Subject: FW: 05533254 Jacktrees Road ,Cleator Moor, Moor Row, Cleator Moor, Cumberland, CA25 5NT
Date: Friday 6 June 2025 at 09:59:46 British Summer Time
From: Stephen Jones
To: Stephen Jones
Attachments: image001.png, image002.png, image003.png, image004.png, image005.png, image006.png, image007.png, image008.png, image009.jpg, image010.jpg, image011.png, image012.png, image013.png, image014.png, image015.png, image016.png, image017.png, image018.png, image019.png, rwyb-emailsignature9_d1ac6220-3e66-47d0-99b8-f0b79b2be61b.png, rwyb-emailsignature2_77969a06-49eb-4946-9cde-d524f2dd047b.png, rwyb-emailsignature3_e339d307-7519-4116-99ab-b97a8201ef3d.png, rwyb-emailsignature4_33a25790-64bf-4554-9187-21f1f366c2cc.png, rwyb-emailsignature5_ab8117f4-4f9d-453d-ae58-a16618ff6c14.png, rwyb-emailsignature6_d5c2eb17-28f3-4419-8fb0-3694715c70fa.png, rwyb-emailsignature7_7c8f9581-b44c-462b-865b-6bb10375f738.png, logos_1_7_72dpi_1576dc77-e6c4-4eaf-9e10-c54cf84d6418.jpg, logos_4_7_72dpi_81b5b95c-6271-4edf-ba3c-ee011bc8ada5.jpg, investors-in-people_e1538419-f187-4b60-a4c7-16e7476be5f4.png

As discussed, I am happy to confirm we will accept surface water flows to the 225mm public surface water sewer

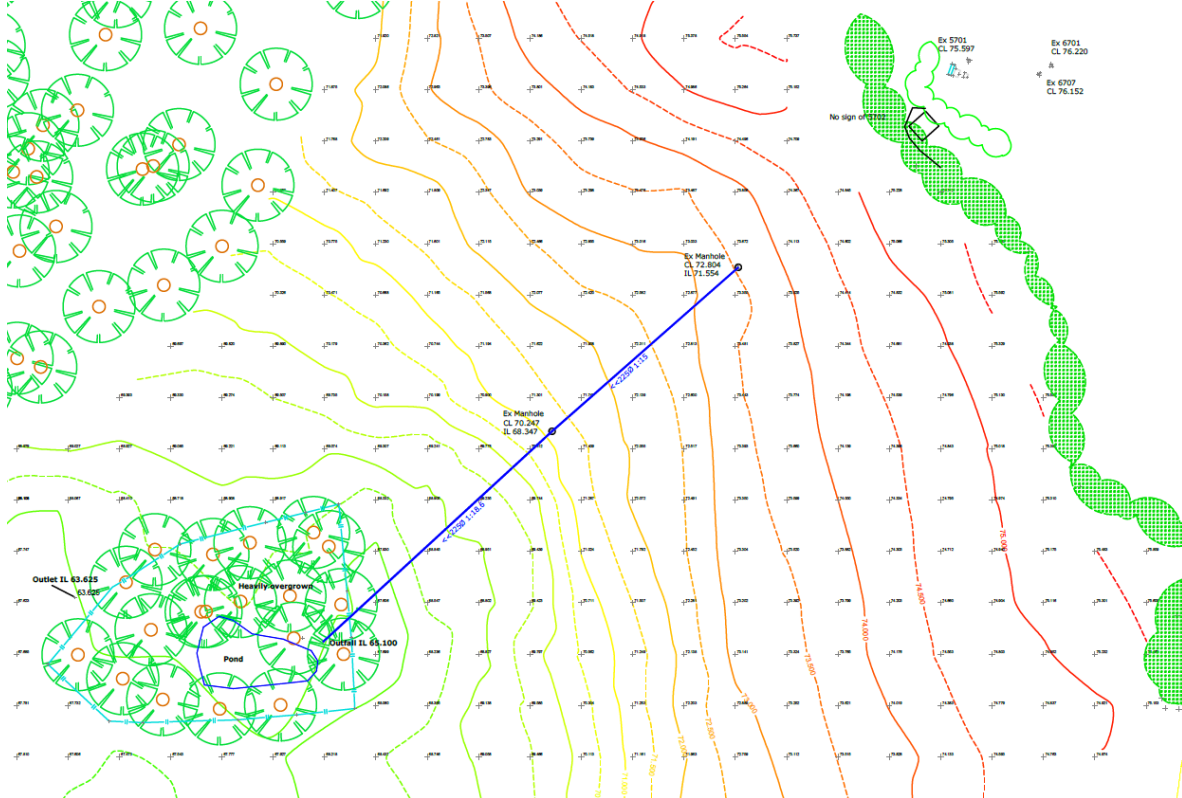
I should have included the extract below of the attached Lidar Survey in my email.

Photo No. 0928

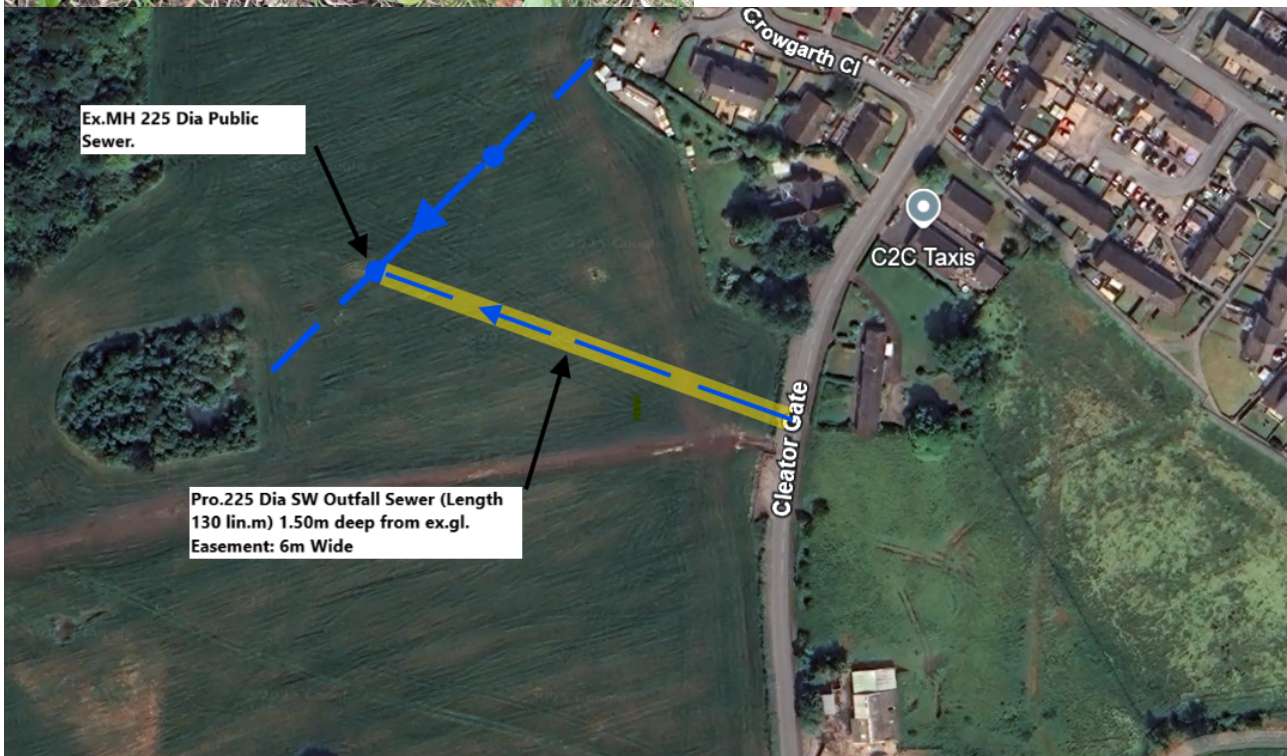
Photos 0928 & 0910 (see screenshot below) show the watercourse and the cover stone over the same to the location of the footpath.

The watercourse can be best described as an overland route rather than a clearly defined ditchcourse suitable for discharging albeit restricted surface water flows from the housing development. Also, the watercourse is located on the farmland adjoining Donaldson Dairy's land, which we have had favourable discussions concerning an easement over their land (see screenshot below).

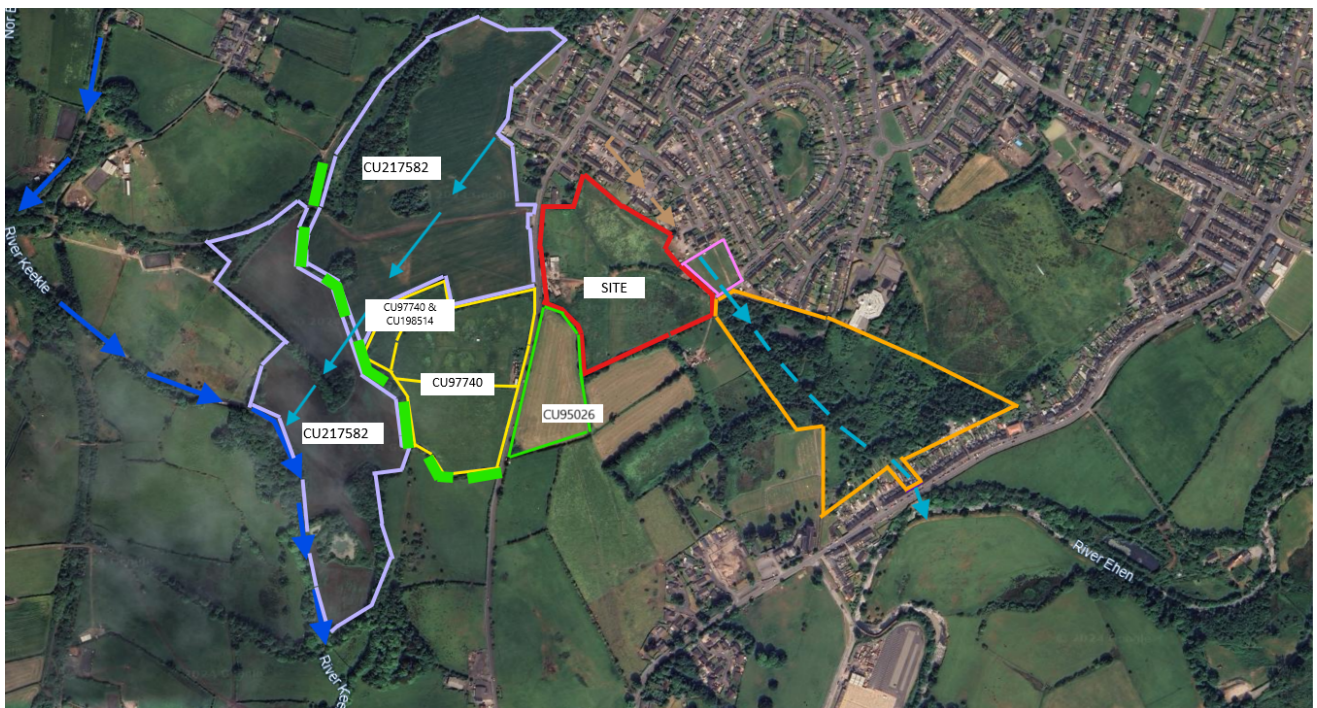
I have entered into discussions with the riparian owner of the parcels of land shown edged Purple (CU217582) and Yellow (CU97740) concerning obtaining their approval to construct the proposed surface water outfall sewer serving our development over their land to the R. Keekle.

I am having difficulty contacting the riparian owner of the land edged Green (CU95026) who no longer lives at the address registered on the 'Official copy of the register of title' for the land. We can't rule out the owner has passed away and there may be complication with the registered title of the land that could take a considerable time to resolve (see screenshot below & attached).

Thank you for detailing the issues with obtaining landowner permissions. To reach a watercourse. I accept a solution which only includes crossing the land marked in purple in your email is required, i.e. I accept the land boundaries marked in green and yellow are unlikely to be possible to cross.

There does appear to be a watercourse on the boundary between the purple and yellow areas, so a watercourse system of some kind may well be reachable without crossing the yellow or green boundaries. I have circled this red in the attached snippet. This is likely where the flows from our surface water sewer (which is mapped to outfall to natural ponds just north) will end up. So another option may be to discharge directly to the same natural ponds that our existing sewer discharges to. These options would need to be explored further, but ultimately if these are explored and properly discounted then I would be willing to accept a connection to public 225mm surface water sewer.
